## **Addendum No. 4**

### **South Dade Regional Library Interior Renovations**

**C23-MDPLS-01-ESP**

**ADDENDUM NO. 4**  
16-JAN-2025

**A-15**

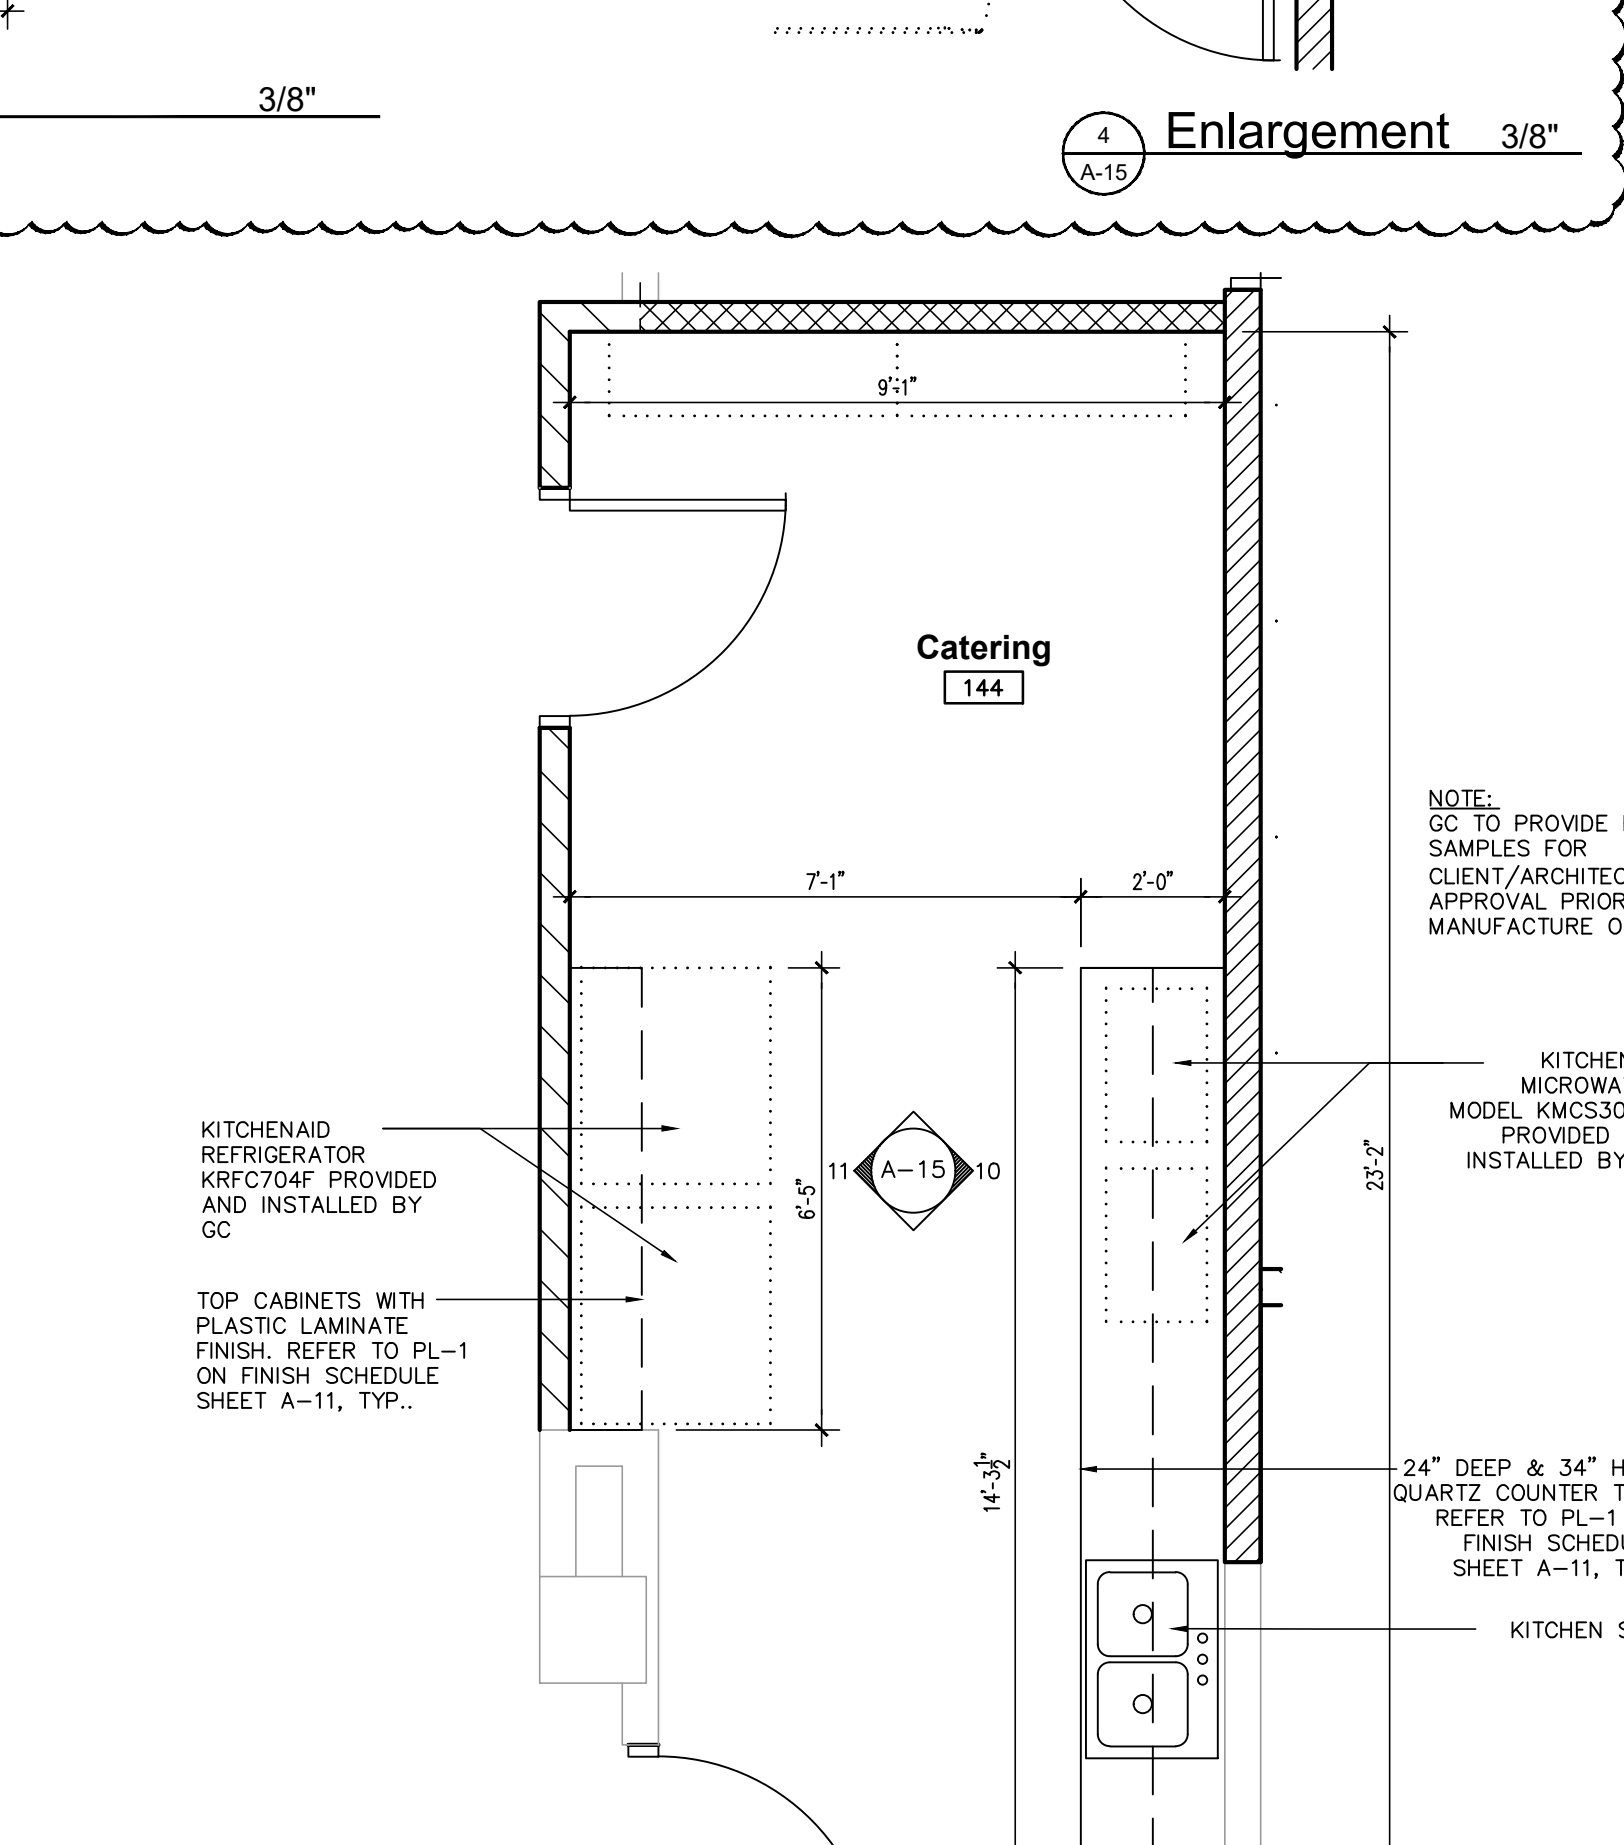
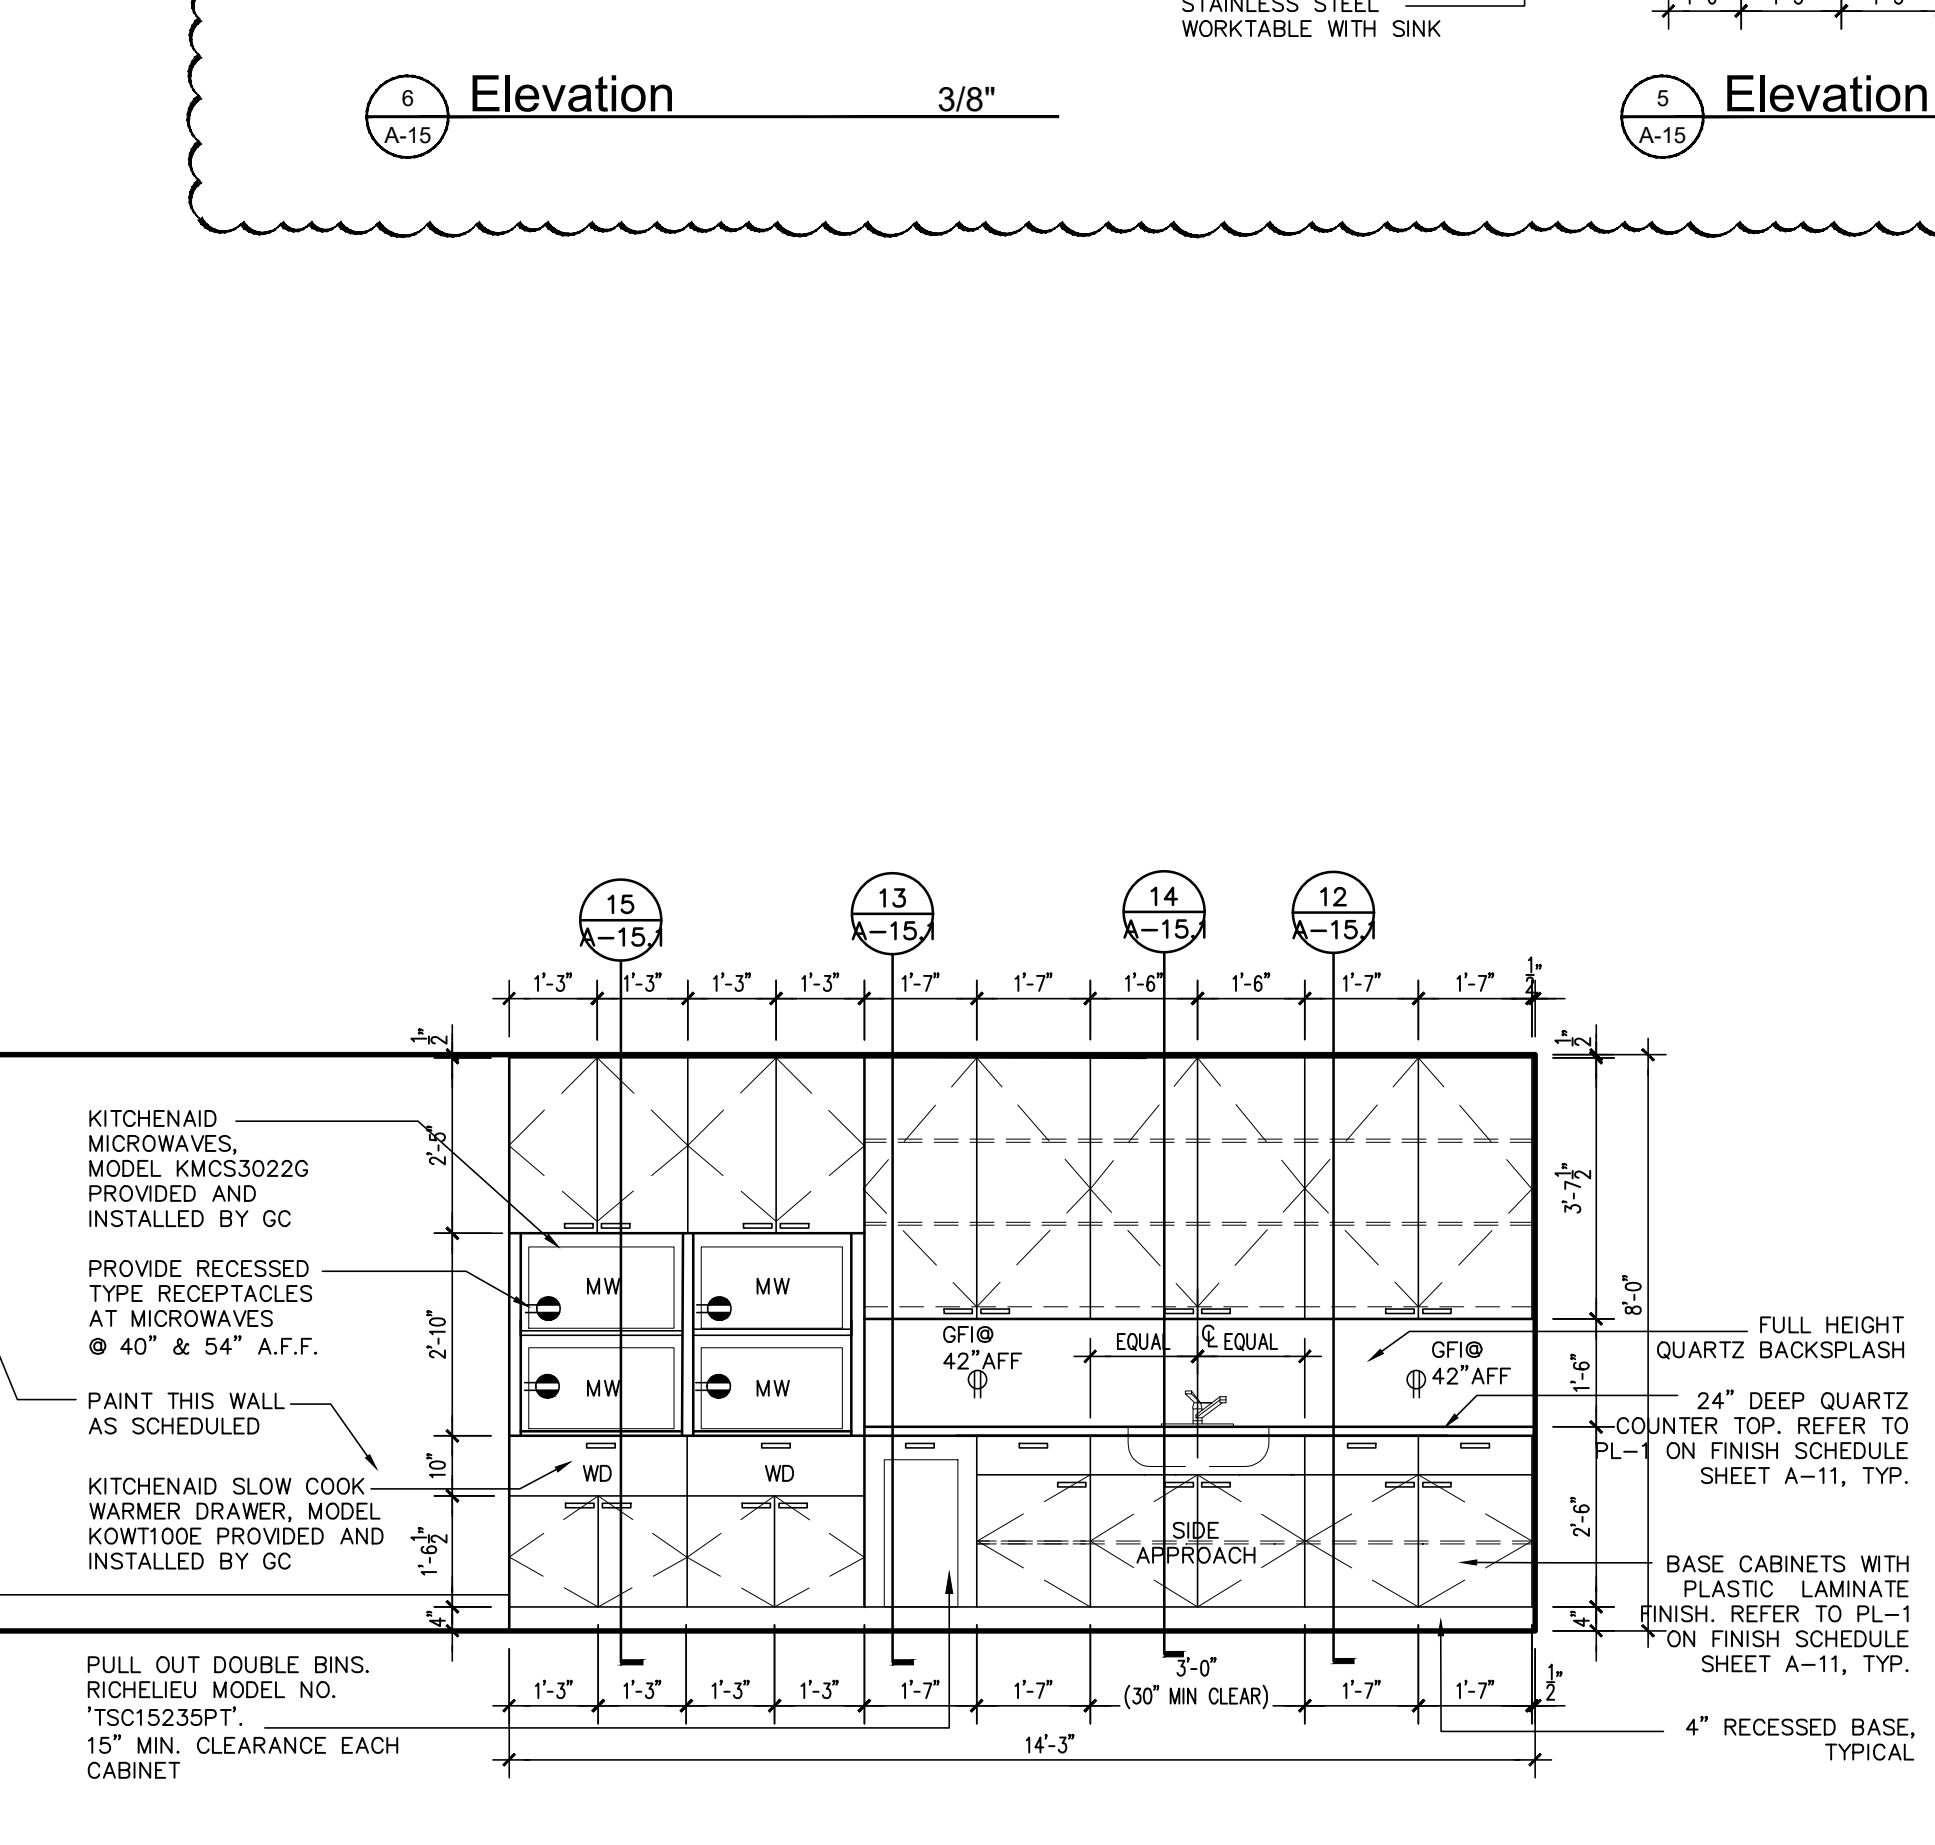
Q60. Plan Sheet A-15 shows a “Grooming Station” at the Catio space, but no manufacturer or model were found. Please clarify if grooming station is to provide and installed by Owner.

**Response Q60: “Grooming Station” refers to a 48”x30” stainless-steel worktable with sink, equal or similar to Uline Model #H-9652L. It should be provided and installed by GC.**

**GC to provide specification sheet for client/architect approval. Refer to revised sheet A-15.**
